Survey Narrative To Comply With O.R.S. 209.250

T35S R1W SEC4 TL401,700 & 800

AFFIDAVIT OF CORRECTION Pursuant to O.R.S. 209.255

I, Larry J. Friar, Registered Professional Land Surveyor of the State of Oregon No. 961, do hereby state that I have discovered a drafting error on that survey for John E. McCaw Jr., filed December 29,1989 as Survey No. 11855 in the Jackson County Surveyor's office.

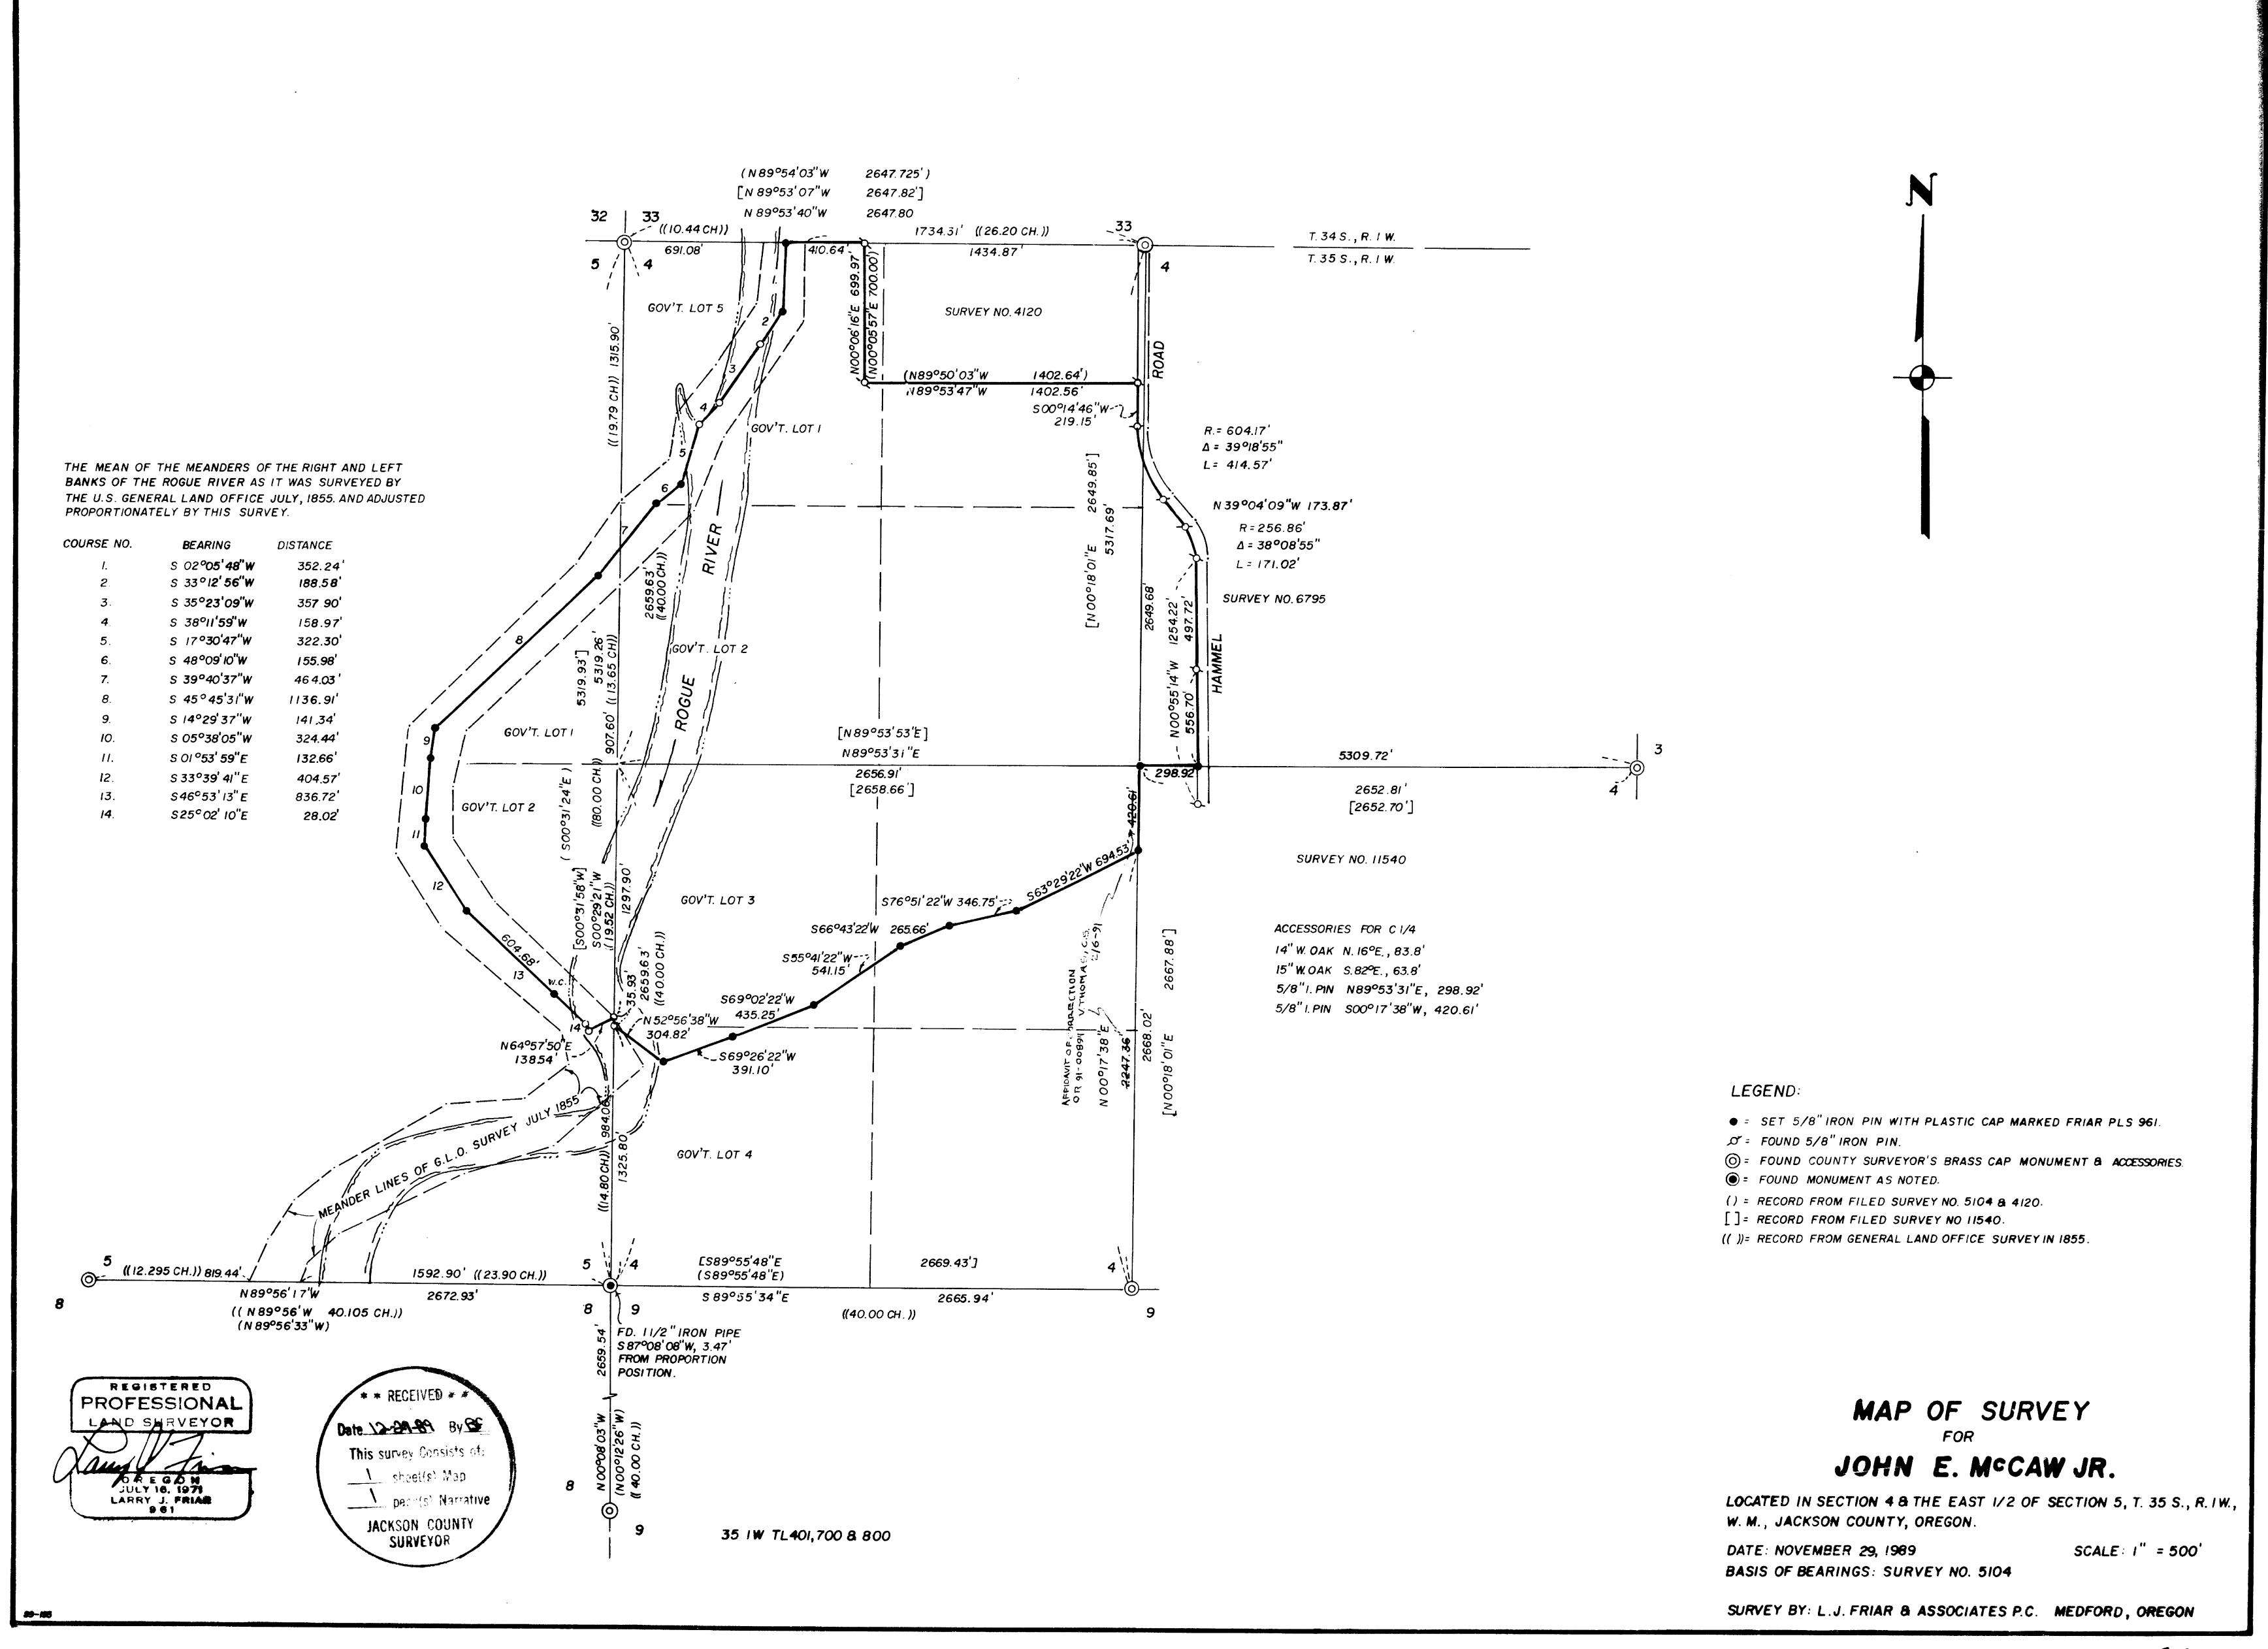
The error is in the course running North $00^{0}17'38"$ East from the 1/4 Corner common to Sections 4 & 9 T.35 S., R.1 W., WM. The distances shown as 2247.36 and 420.61 should be 2237.46 feet and 430.56 feet respectively.
